VIEUX CARRE COMMISSION

AGENDA

WEDNESDAY, SEPTEMBER 20, 2023

ADDRESS: 822-24 N. Rampart St.
 OWNER: North Rampart Properties APPLICANT: John C Williams
 LLC
 ZONING: VCC-2 SQUARE: 103
 USE: Mixed LOT SIZE: 4950 sq ft approx.

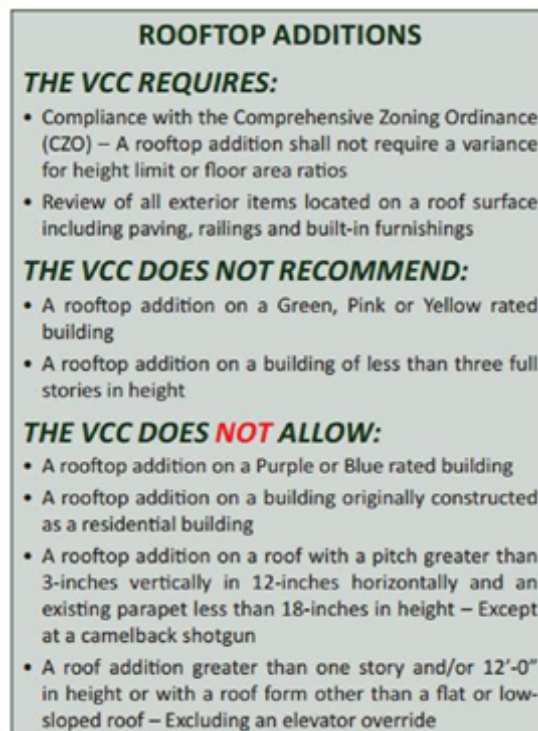
The applicant proposes to add an 868 sq. ft. roof deck at the front half of the Brown rated flat roof, set back 4'-6" at the front elevation and approximately 8'-6" at the side elevations. The applicant stated that the roof deck will be open for shared use by the residential units, but not the first floor commercial space, which is currently vacant. The railing is a simple tension cable rail 3'-6" in height. Given the height of the roof deck itself, the overall additional height measures 4'-1". The rooftop access stairway is already existing.

While final information has not been submitted for items such as paving, the proposed roof deck meets all other the requirements for rooftop additions per the original Design Guidelines. The supplemental Guidelines for rooftop additions do not apply, as there is no commercial use proposed. The Committee recommends **conceptual approval** of the proposed roof deck. All finishes, or any other elements that may not be considered furniture, such as lighting, must be submitted for review and approval at staff level prior to permit.
